Our ref: 11014-ltr-008
Date: 8th December 2017

RE: Birdwood Park RSL LifeCare Development
No.510 King Street., Newcastle West 2300
DA 2016/00654
SUMMARY of SECT.96 REVISIONS

Please find following below, a summary of the key 'major' & 'minor' revisions, forming the Section 96 submission, to the approved DA.

APPENDIX 6 – LEVEL 5 FLOOR PLAN COMPARISONS

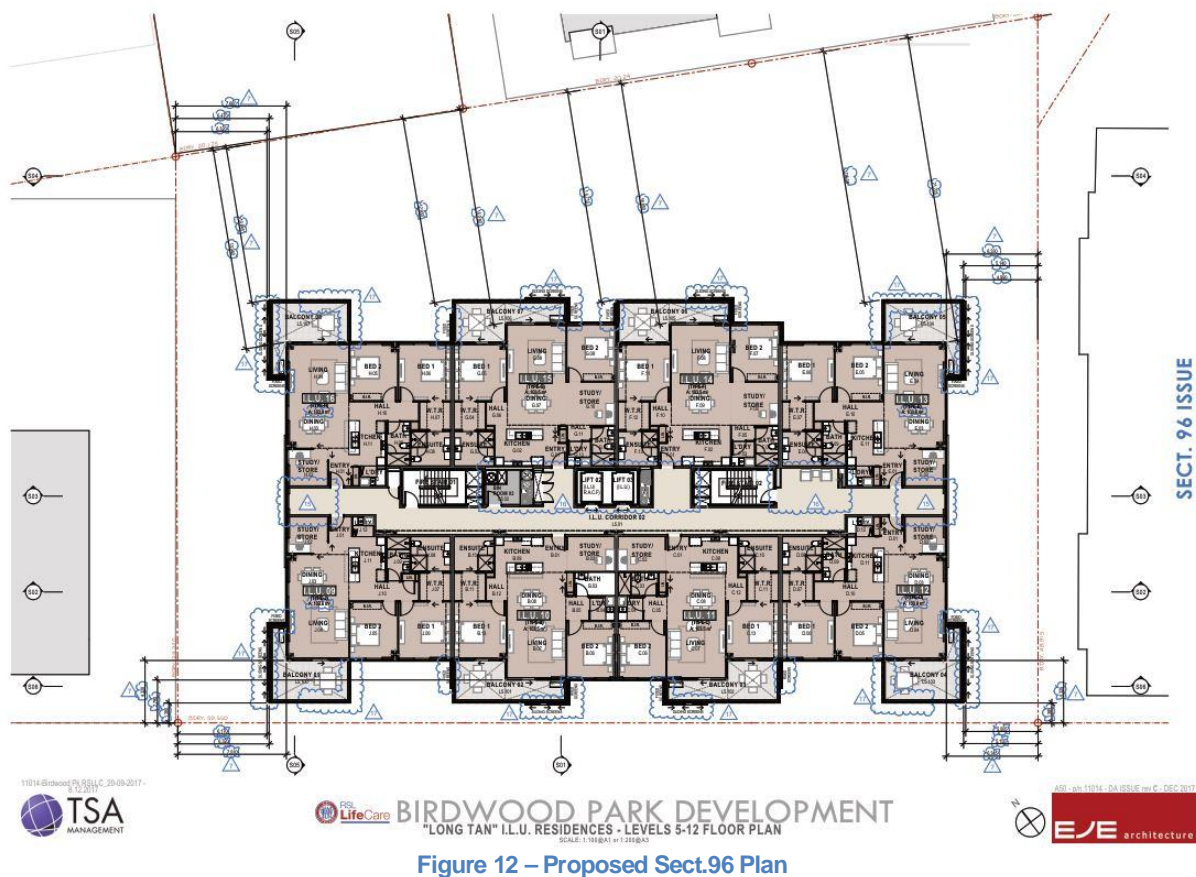
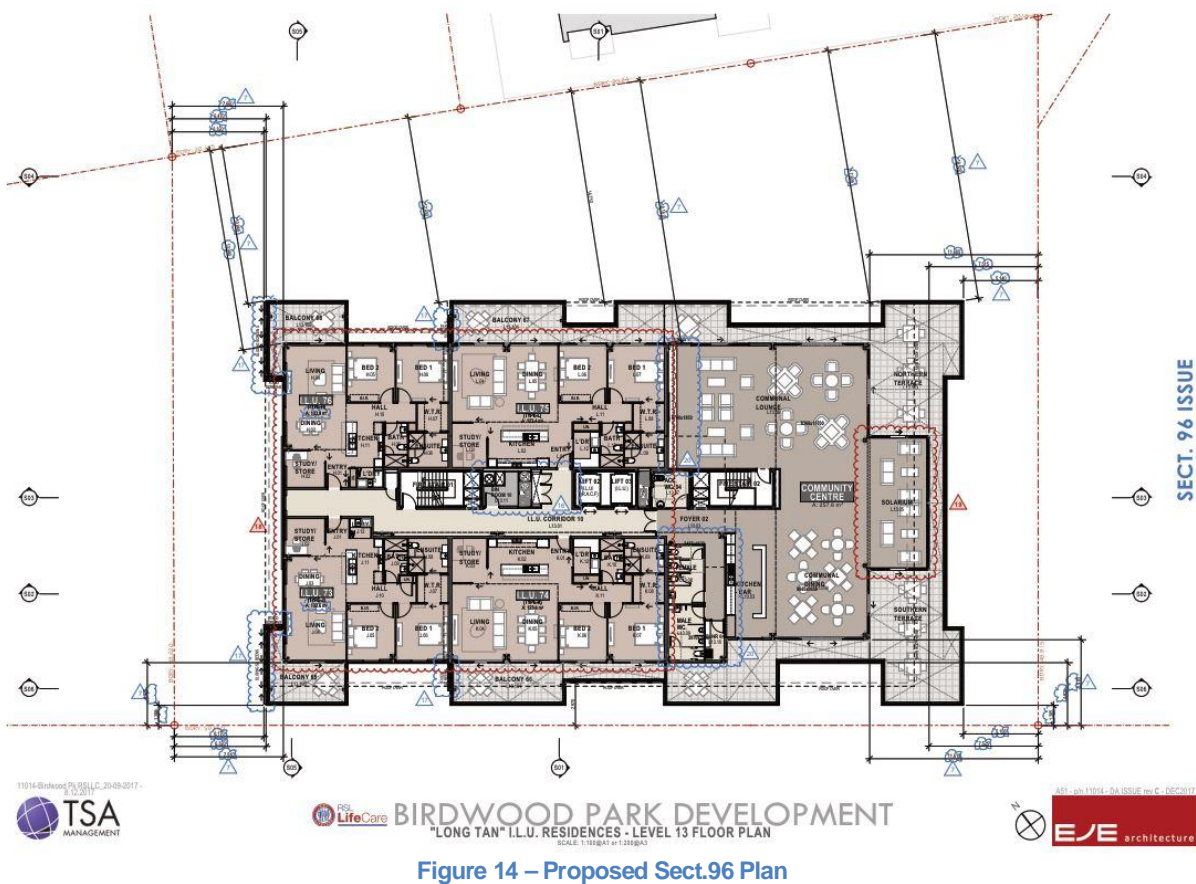
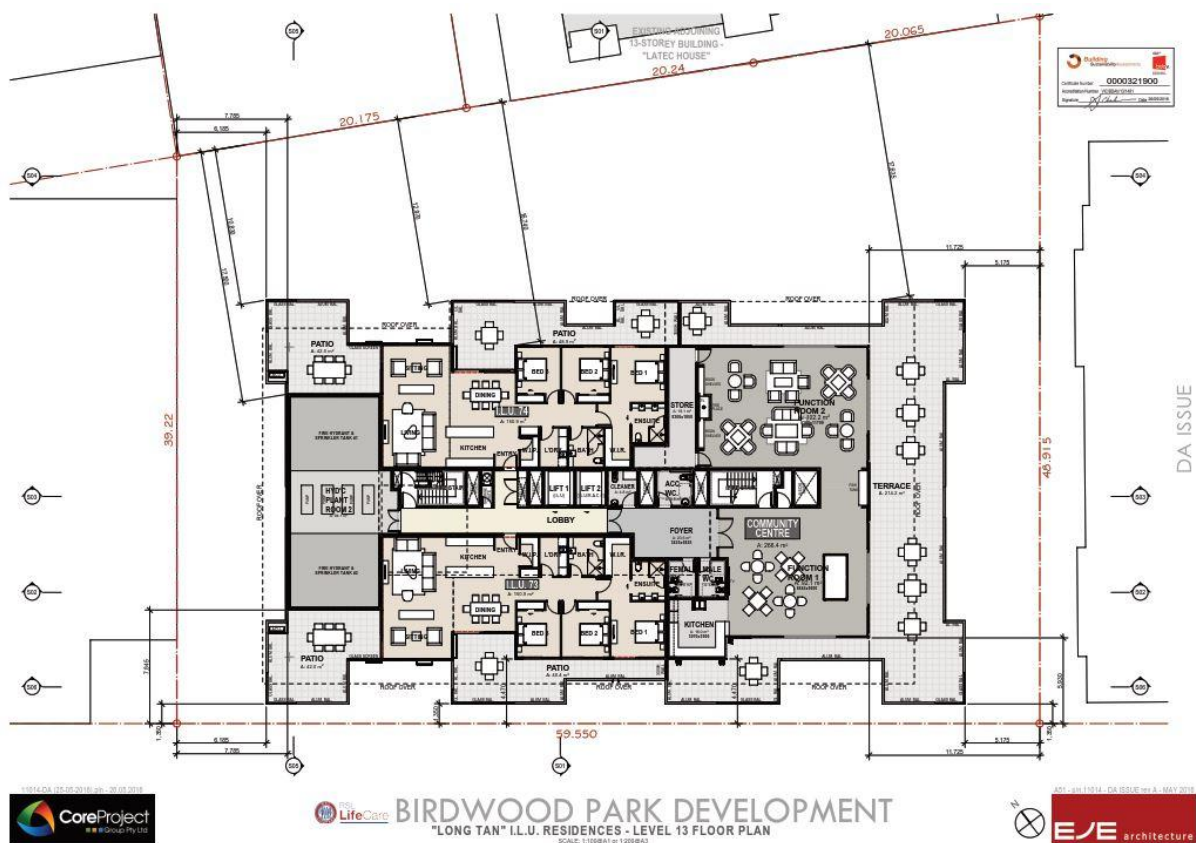
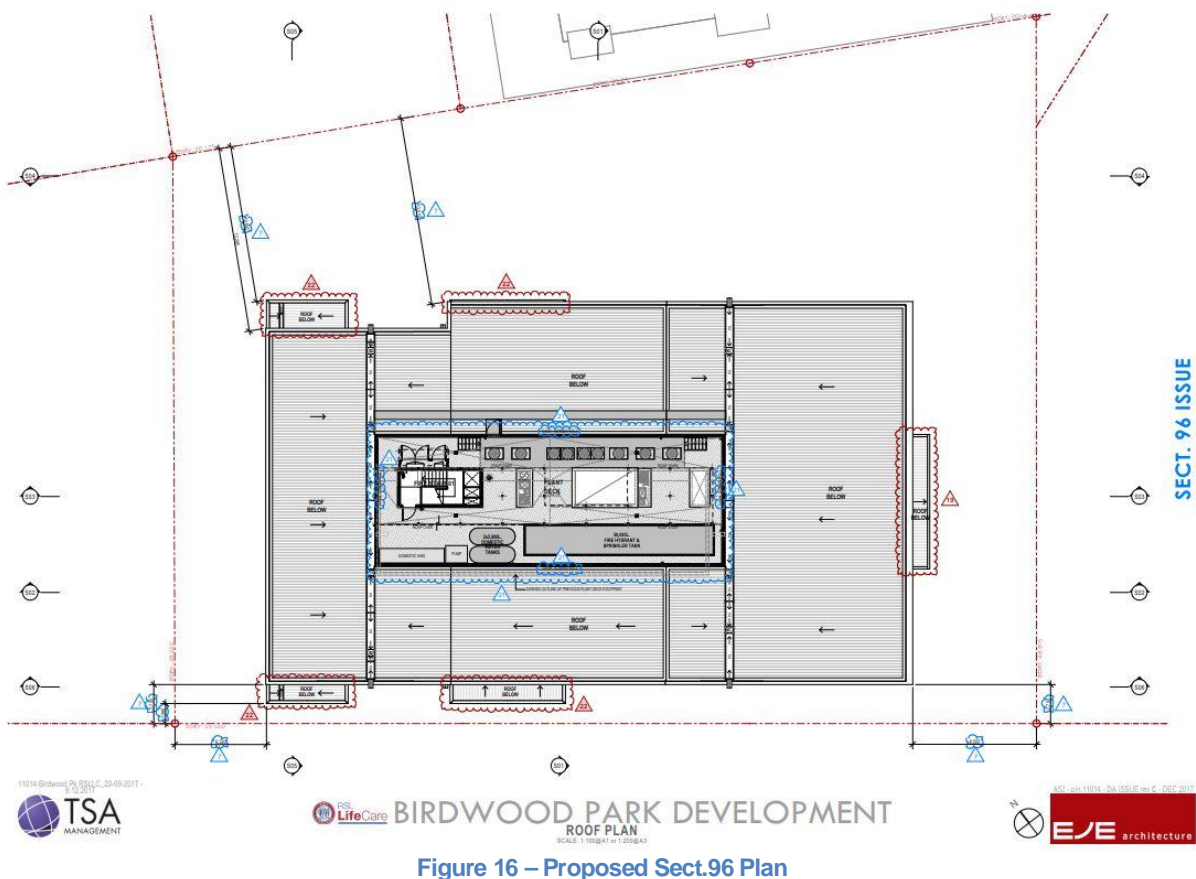
- 7 – minor boundary setback revisions (*note):-
 - at NE corner:-
 - § from 6.525m to 6.30m for ILU facade to east;
 - § from 5.175m to 5.14m for balcony to east;
 - § from 17.635m to 17.605m for balcony to north; &
 - § from 21.295m to 21.125m for ILU facade to north;
 - at SE corner:-
 - § from 5.175m to 5.155m for balcony to east;
 - § from 6.525m to 6.345m for ILU facade to east;
 - § from 4.35m to 4.325m for ILU facade to south; &
 - § from 1.35m to 1.385m for balcony to south;
 - at SW corner:-
 - § from 6.185m to 6.32m for balcony to west;

- § from 7.535m to 7.510m for ILU facade to west;
- § from 4.35m to 4.32m for ILU facade to south; &
- § from 1.35m to 1.38m for balcony to south;
- o at NW corner:-
 - § from 6.185m to 6.47m; from 7.535m to 7.66m; from 10.830m to 10.845m; & from 14.01m to 13.94m;
- 15 – external alcove space at ends of public corridors enclosed & public corridors extended into;
- 16 – internal core layout of Lifts, Lobbies, Bin Room, service riser shafts revised;
- 17 – revised balcony screening & balustrade treatment (simplified based on solar control & privacy considerations; NE & NW obscure louvers removed to allow solar access considering adequate separation distances for privacy to adjoining Latec House);

APPENDIX 8 – LEVEL 14 FLOOR PLAN COMPARISONS

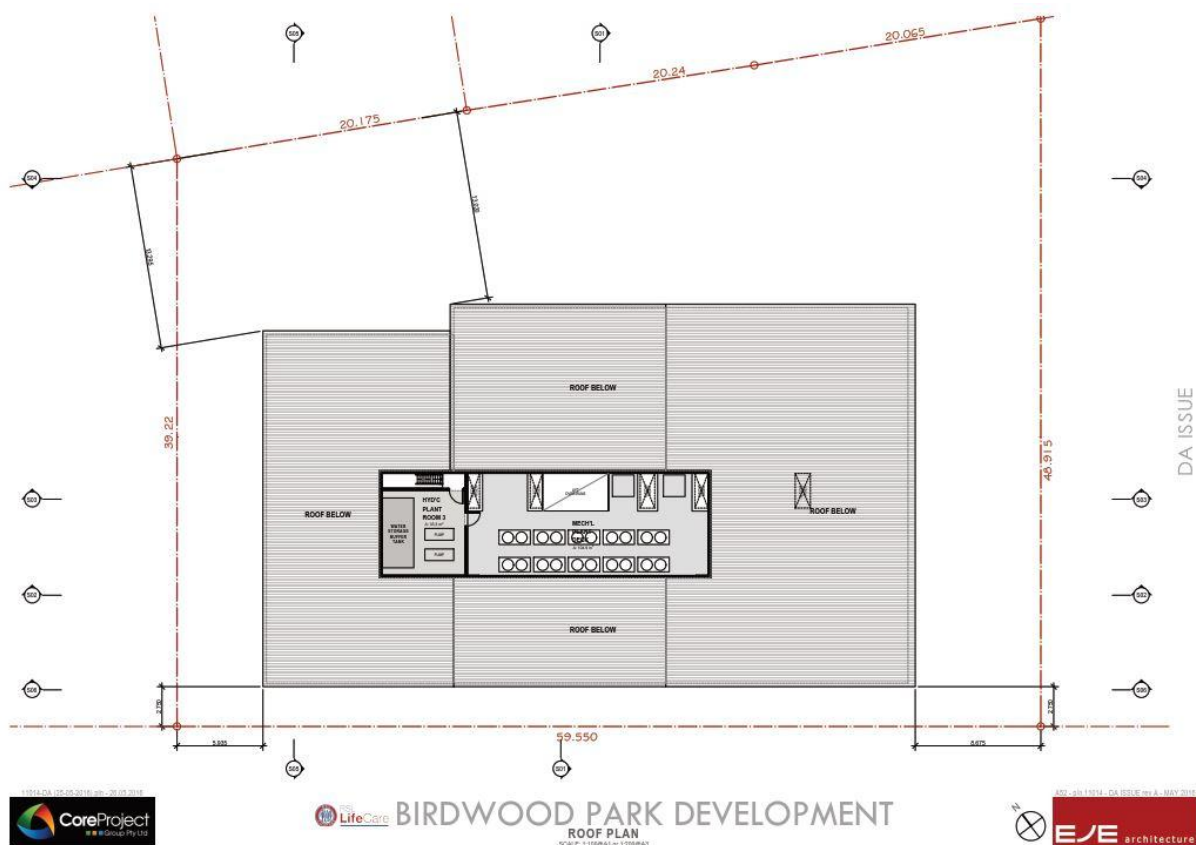
- 7 – minor boundary setback revisions (*note):-
 - o at SE corner :-
 - § from 8.65m to 8.55m; & from 2.75m to 2.695m;
 - o at SW corner:-
 - § from 5.935m to 6.27m; & from 2.75m to 2.695m/1.38m;
 - o at NW corner:-
 - § from 13.295m to 10.845m; & from 13.02m to 13.01m;
- 19 – 'Solarium' addition to Community Centre over external terrace area below;
- 21 – Plant Deck footprint revised as follows to suit developed services design & relocation of level 13 plant;
 - o southern edge reduced 0.58m further back from street boundary;

- eastern edge extended 1.15m further towards east boundary;
- northern edge extended 2.27m further towards north boundary;
- western edge extended 0.15m further towards west boundary;
- & perimeter screens wall heights reduced from 3.2m to 2.4m high;
- & flat roof added over part of deck area to provide cover to equipment;
- **22** – flat roofs added to new level 13 ILU balconies below for weather protection;

APPENDIX 9 – SW ELEVATION COMPARISONS

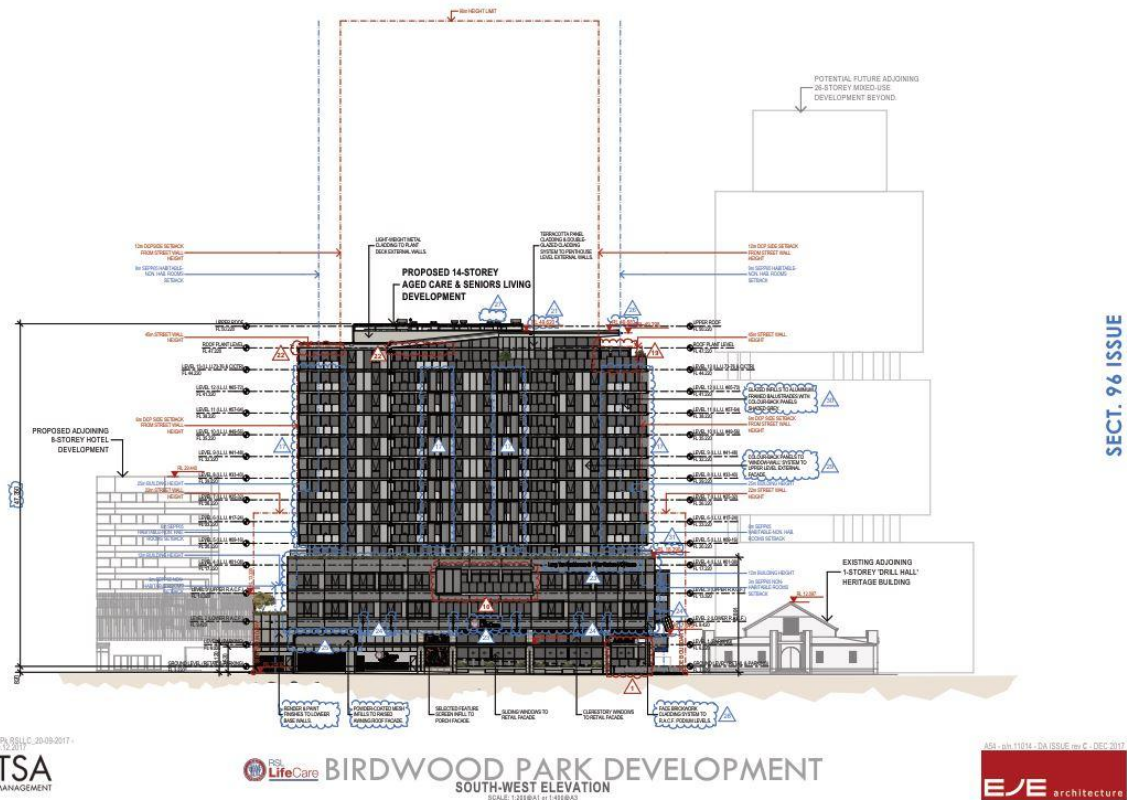
- **1** – Alfresco area enclosed as part of internal Retail Space; & Porch, steps, & column alignment revised;
- **10** – proposed new street facing balcony on Level 3 RACF overhanging the front boundary alignment;

- **17** – revised balcony screening & balustrade treatment;
- **19** – ‘Solarium’ addition to Community Centre over external terrace area (*separate flat roof located under approved main roof-line);

- **21** – Plant Deck perimeter screens wall heights reduced from 3.2m to 2.4m high; & flat roof added over part of deck area to provide cover to equipment;

- **22** – flat roofs added to new level 13 ILU balconies below for weather protection;
- **23** – minor modifications to the design intent of proposed facade signage;

- **24** – facade/wall-mounted tilted flag-masts (approx. 1.0m x 1.6m flag size; x approx. 12 flags) added to perimeter of level 2’s southern & eastern facades (to symbolise the nations forming part of the ‘allied forces’ in the World Wars);

- **25** – raised section added to level 1’s street awning roof to assist in identifying the vehicular entrance into the facility & to conceal location of mechanical plant within (height to match raised awning roof section at SE corner’s main entrance);

- **26** – minor modification to main roof’s overall maximum height (i.e. raised 0.385m in part [from RL 49.298 to RL 49.683] due to design development of roof construction techniques & detailing).

- **27** – flat roof added over small part of Plant Deck area to provide cover to equipment;
 - *note:- overall maximum height raised 0.15m [from RL 50.420 to RL 50.560] for new plant roof (new flat roof 0.1m higher than previous perimeter screen walls, & setback significantly further than screen walls, & therefore generally not visible from street level);

- **28** – ‘floating’ podium facade cladding (i.e. levels 2 & 3; RACF) revised from terra-cotta coloured ‘Terra-Cade’ type to mid-brown coloured face brickwork;

- **29** – ‘tower’ facade solid infill cladding (i.e. levels 4-13; ILU’s) revised from aluminium composite panel type to colour-back glazing panels;
- **30** – ‘tower’ balcony balustrade materials (i.e. levels 4-13; ILU’s) revised from aluminium composite panel type to colour-back glazing panels;

- **31** – minor modification to podium level (i.e. level 4) overall maximum perimeter facade/balustrade height (i.e. raised 0.15m [from RL 18.120 to RL 18.270] due to design development of terrace balustrading detailing & safety considerations).
